REMARKS

Claims 15 to 21 are now pending in the application. Applicants reserve the right to file one or more divisional applications with the unelected claims.

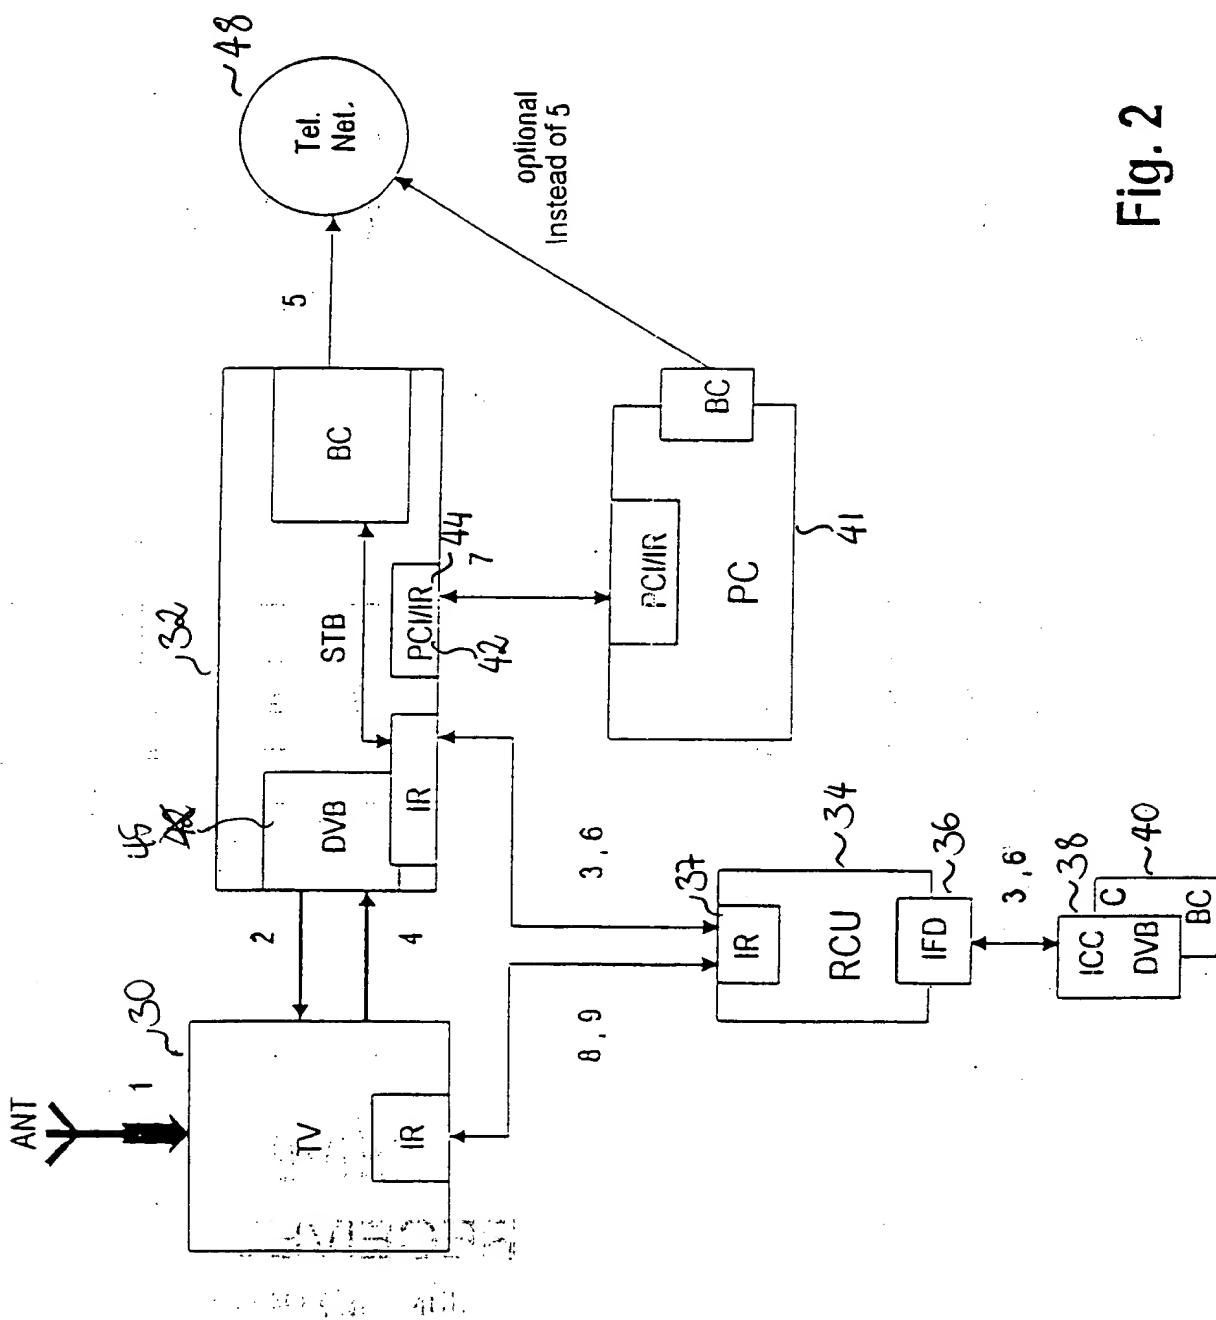
Specifically, Fig. 1 was objected to for STB being labeled 72, and no heading of "Prior Art." Applications have amended Fig. 1 so that STB is labeled 12 and there is a heading of "Prior Art" as suggested by the Examiner. No new matter has been added. Specifically, Fig. 2, was objected to for RCU being labeled 34 while it was referred to as 42 in the Specification. For this and other typographical errors, Fig. 2 has been amended, and, the Specification has been amended so that the description of Fig. 2 is consistent with the drawing of Fig. 2. No new matter has been added. Accordingly, Applicants submit that the Drawings have been amended in accordance with the Examiner's requests and all objections to the Drawings have been overcome. Withdrawal of the objections to the Drawings is respectfully requested.
